AG 360 Handle Proximity Sensor Bracket Change

- New Bracket

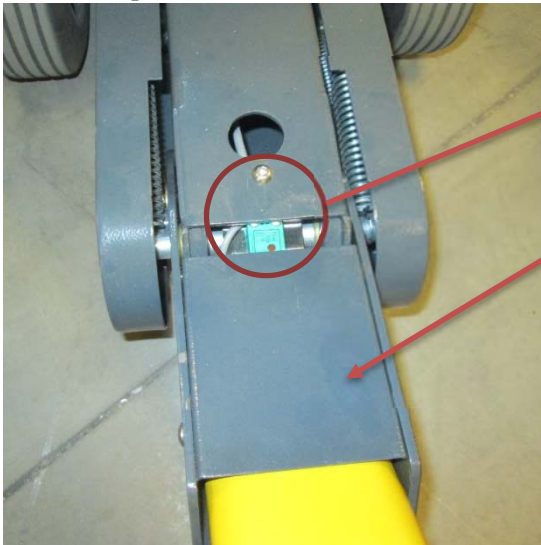
This bulletin is to inform distributors that the original bracket for the handle proximity switch on the AG-360 has been re-designed. The original routing hole size for the proximity sensor cord was increased to help prevent the cord from pinching in the handle during operation. Any machine that shipped after the issue date of this bulletin has the corrected bracket already installed. Any machine that shipped prior to this date may have the original bracket. The new bracket mount is drawing number 1026203.

Increased Wire Routing
Hole Size

Remove the handle
back plate (4 Phillips screws)

- Remove the Allen screw from the proximity sensor bracket.

- Remove the two Phillips screws that attach the proximity sensor to the original bracket and backplate.
- Using the same two screws, attach the proximity sensor to the new bracket and backplate.

- Re-attach the proximity sensor bracket.
- Re-attach the handle back plate.
